ABBREVIATED BRIDGE CONDITION REPORT

FAI Route 57
Section 38-2HVBR & HVBR-1
Iroquois County
P93-041-00

I-57 over FAS 317 (Old Rte 45) and ICG RR

SN 038-0013

GENERAL PLAN & ELEVATION
PROJ. I-IG-57-6(39) 297
F.A.I. RT. 57 OVER S.B.I. RT. 25 & I.C.R.R.
F.A.I. RT. 57 SEC. 38-2HVB
IROQUOIS COUNTY
STA. 1037+61.38

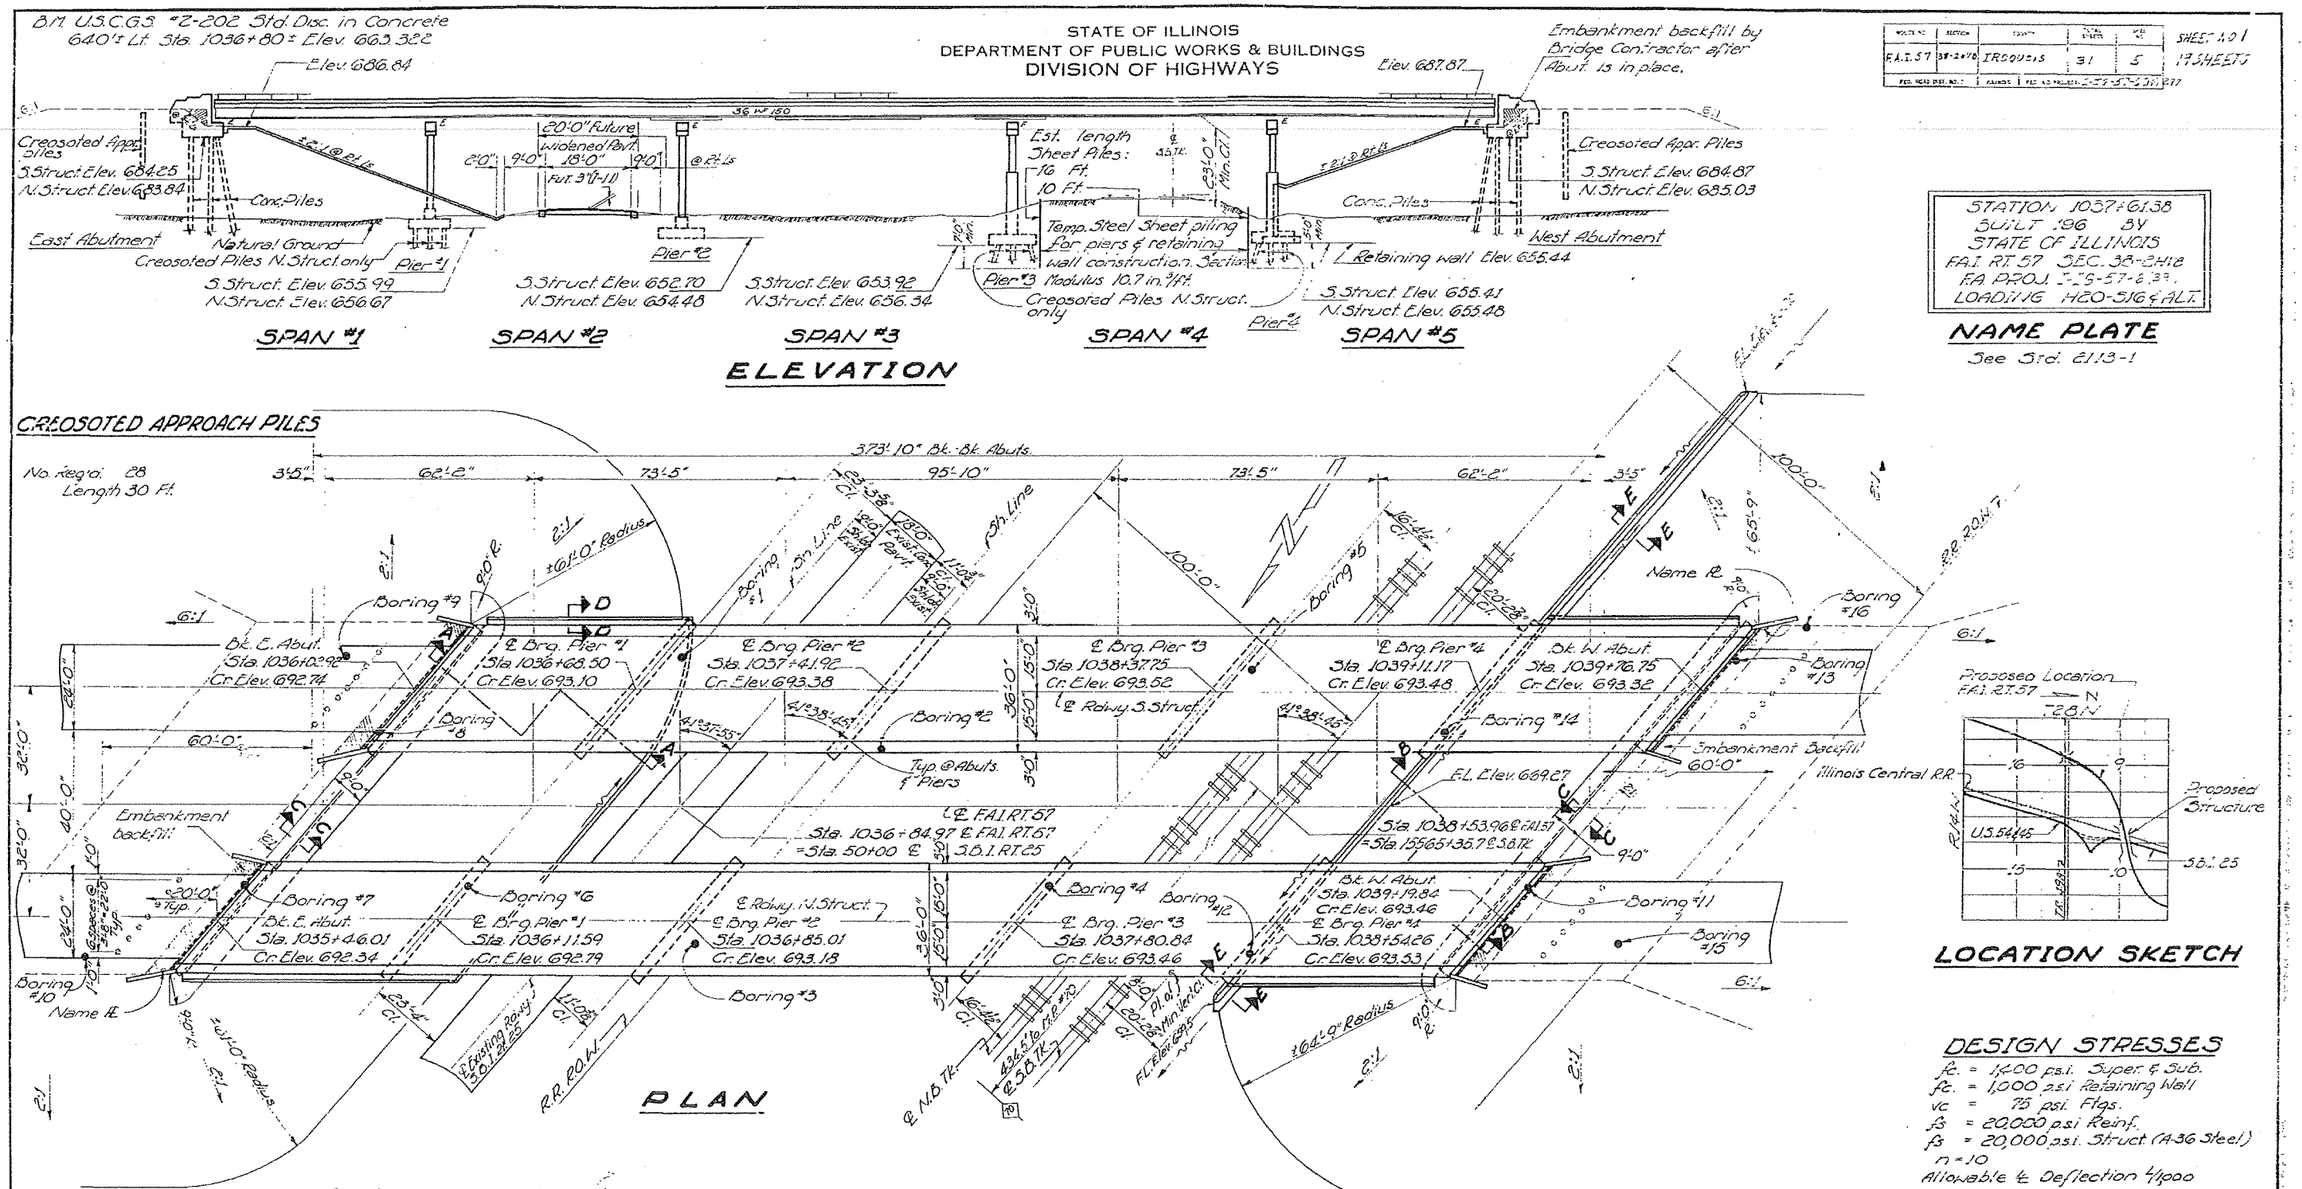
I checked the local roads manual and the piers are within their clear zone limits. This plus the fact that the pier/column walls are very high on the severity index for roadside hazards leads me to agree with you that the crashwalls adjacent to the roadway should be raised to 4'.

Wanted to get your opinion on this. I'd recommend that we increase the crashwall heights at the piers, not adjacent to the RR tracks, to 4' as mentioned below. We have been doing this on all of our interstate overheads. I realize that this is a state route underneath, but I'm thinking it follows the same safety aspect logic. I've attached a plan sheet of the bridge for you.

Also, the Bridge Manual requires multi-column pier crashwalls which are not adjacent to RR tracks to extend 4' above ground level. Piers 1 and 2 have very short crashwalls that do not extend above grade. Pier 2 is approximately 10' from the edge of pavement and has guardrail attached to the columns. Pier 1 is in the slopewall and little further away from the pavement, so it's somewhat protected. The 2002 ADT was 1800 with only 7% trucks. Do you recommend increasing the height of these crashwalls or leaving them as they are?

I'd say we prefer to raise the crashwalls adjacent to the roadway to 4'.
